JORDAN **REVISION LIST - STRUCTURAL:**

Lot 321 OAKMONT **INVENTORY MARKED**

JORDAN **REVISION LIST - ARCHITECTURAL:**

DATE: MARCH 15, 2019
REV.: MAY 01, 2020
SCALE: 1/4"=1'-0"
DRAWN BY:
ENGINEERED BY:
REVIEWED BY:
first floor plan A-6

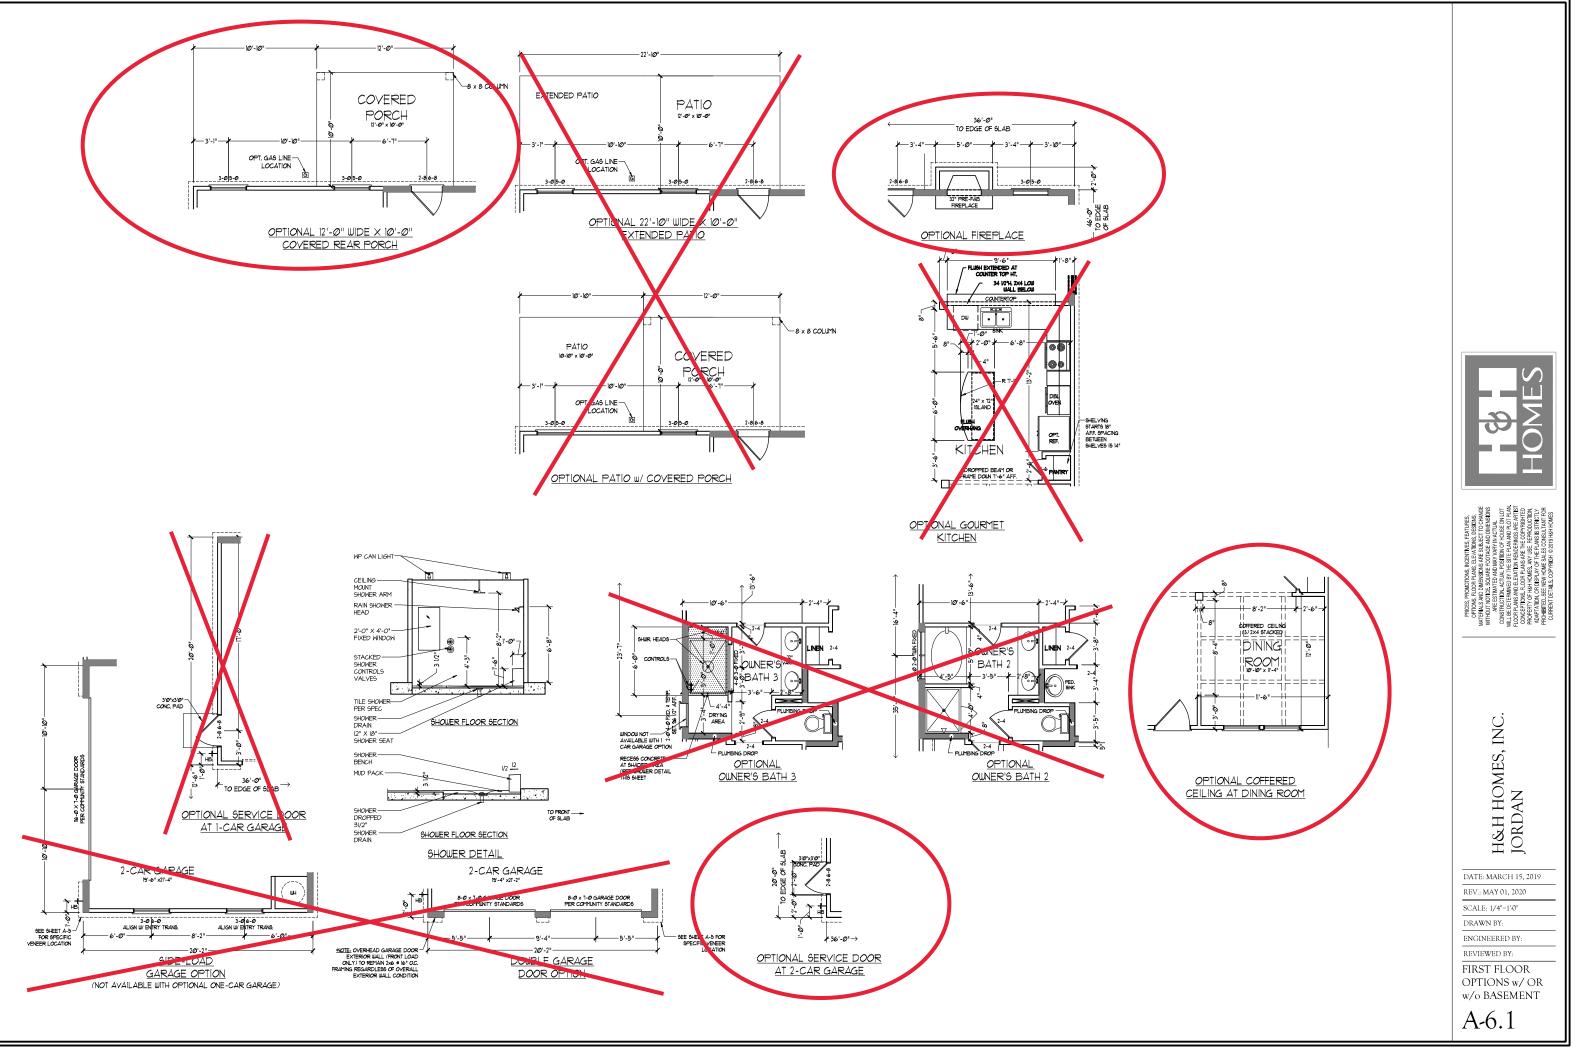
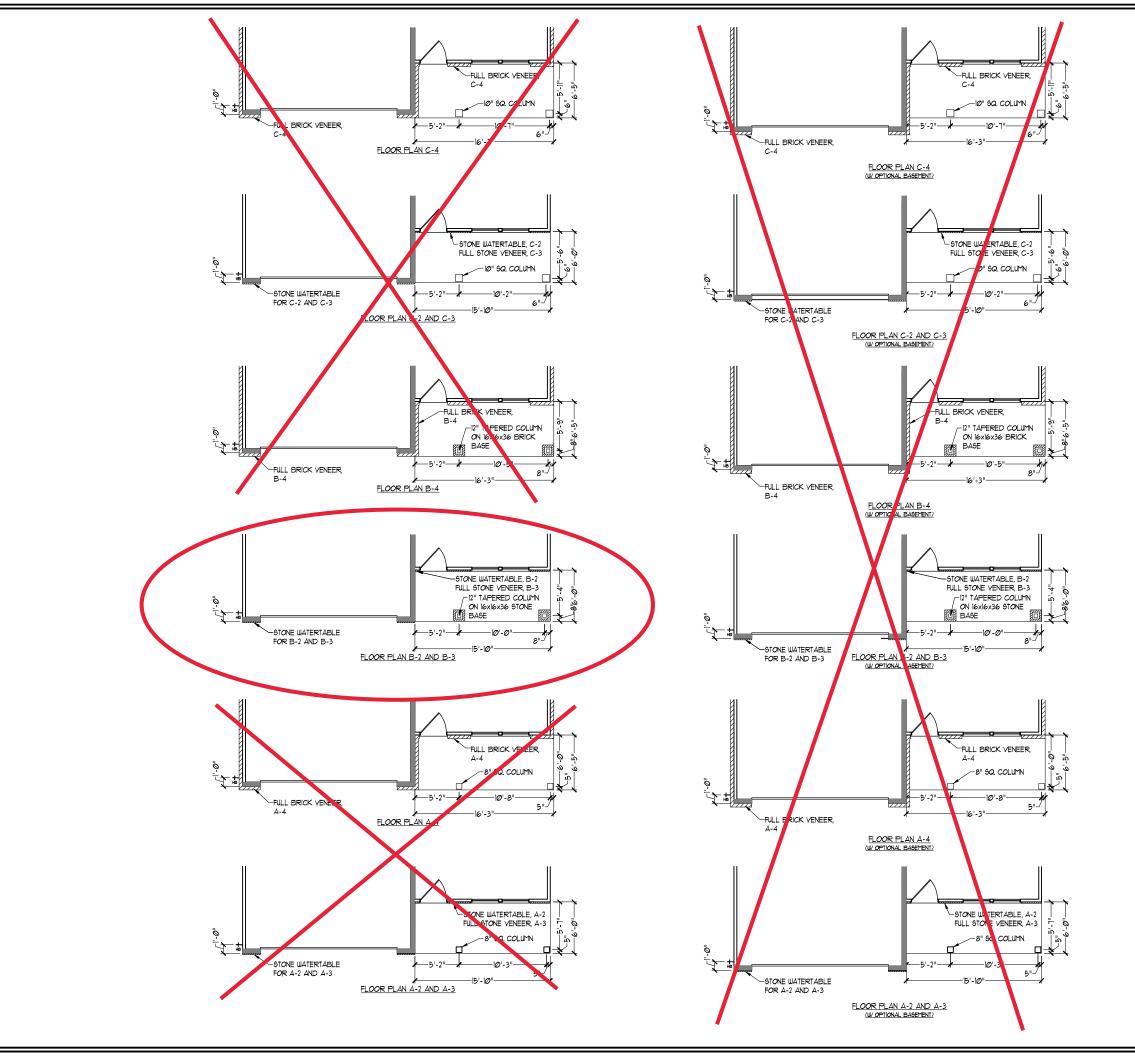
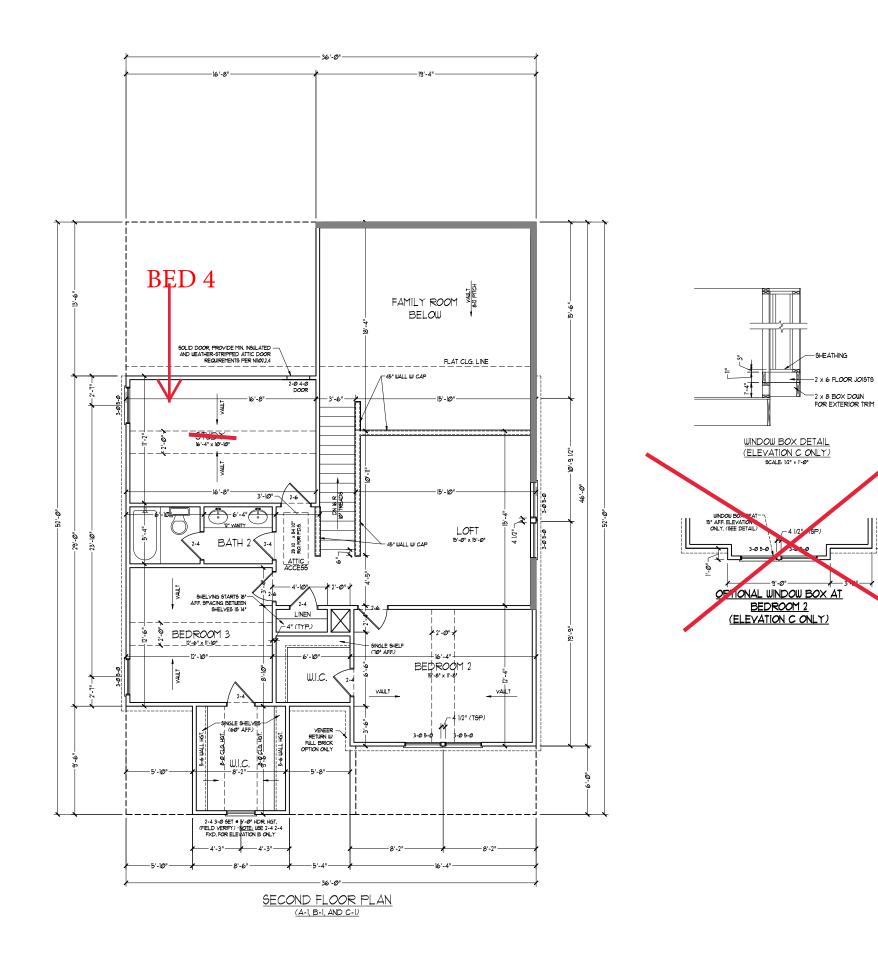
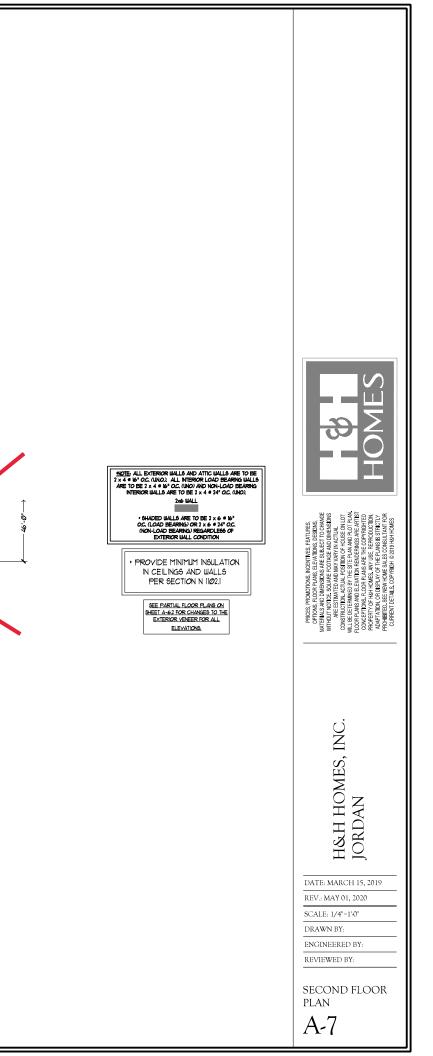
- CHANGED SWING OF SERVICE DOOR IN GARAGE TO OUT SWING (SEE SHEET A6.1) (7-8-20)
- REMOVED LIGHT IN SECONDARY BATH OVER TUB/SHOWER COMBO (7-8-20)
- REMOVED "RECESSED ENTERTAINMENT BOX" OVER FIREPLACE (7-8-20)
